Village of Arlington Heights
Plan Commission
Board Room
Arlington Heights Village Hall
33 S. Arlington Heights Road
Arlington Heights, IL 60005
February 22, 2017
7:30 PM

- A. Arlington Heights Police Station - 200 E. Sigwalt St. - PC#16-024
Amendment to PUD Ordinances 05-041 and 78-026

Plan Commission Hearing Police Station Round 1
Planning & Community Development Landscape Comment Responses
Charles Witherington-Perkins

Attachment:
PCC Pavement detail

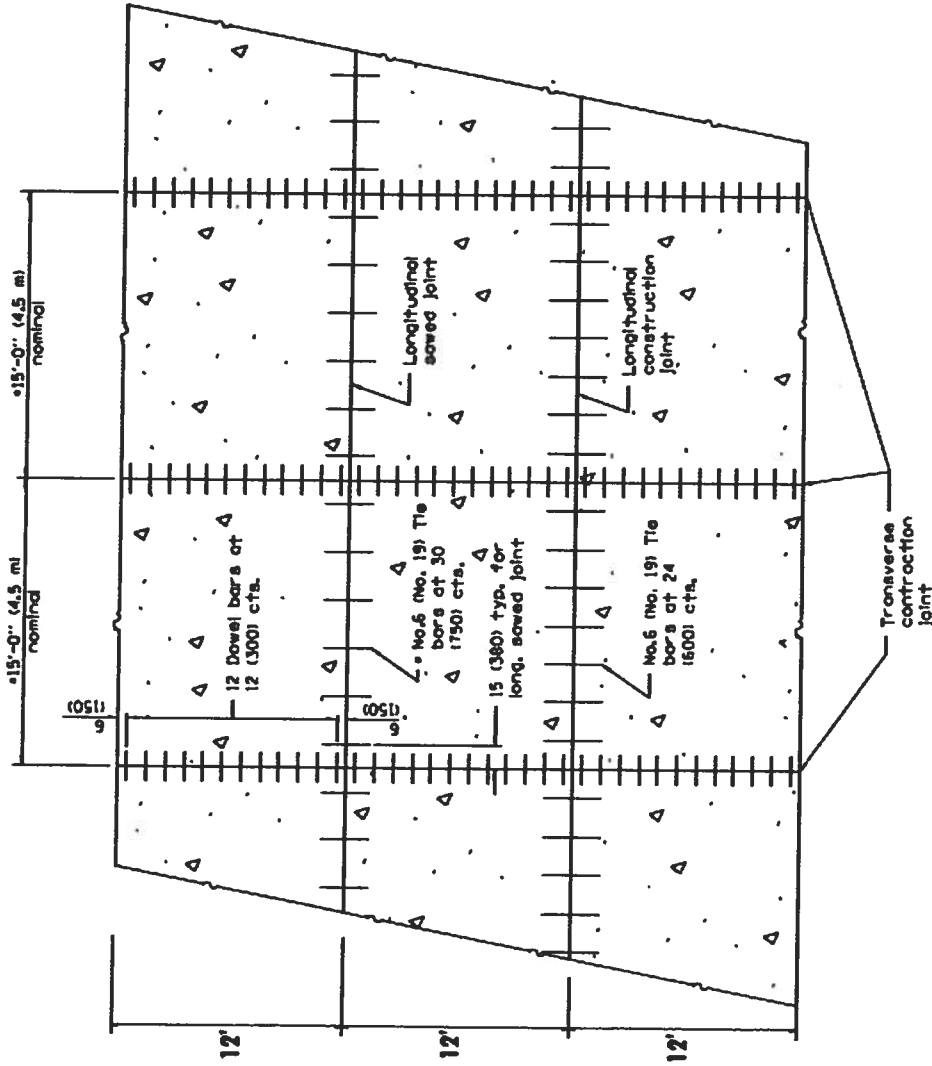
51. The response made by the petitioner to comment #27 is noted. Sheet C-104: The PCC pavement section shall match the recently completed Fire Station 4 concrete driveway pavement section: 10" PCC Concrete, 4" CA-6 Stone Subbase, transverse 1-1/2" dowel bars, longitudinal #6 tie bars. See attached detail.
